FIRE SAFETY INSPECTION REPORT

Apparel Gallery Ltd. (Extended Building)

Date: 24 May 2021

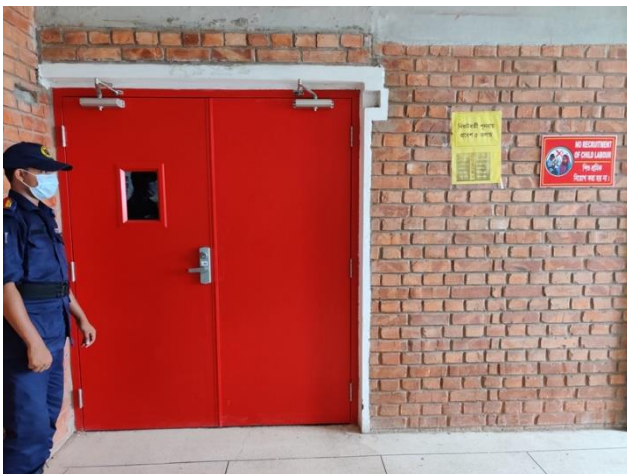
F-1	Fire Rated Construction	Storage from all floor discharges directly into the exit stair discharge.	Openings from exit enclosure to storage room, generator and transformer spaces shall be provided with a vestibule with fire rated construction and openings. Provide a 1.5 hr. fire rated door on the exit stair side and a 1-hr. fire rated door on the Store, generator, sub-station room side. Ensure that the fire rating of the vestibule construction matches that of the exit stair enclosure.	Within 3 months
-----	-------------------------	---	---	-----------------

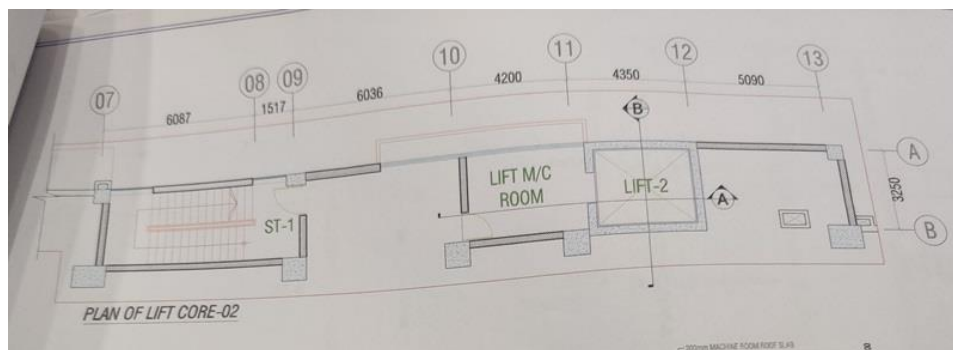
F-5	Egress	Width of exit stairs is less than 1.5 m (60 in.) (S-W and S-E stairs).	Provide exit stair minimum clear and unobstructed width of 1.5 m (60 in.) in accordance with Accord standard 6.5.6.2.1.	Within 4 months
-----	--------	--	---	-----------------
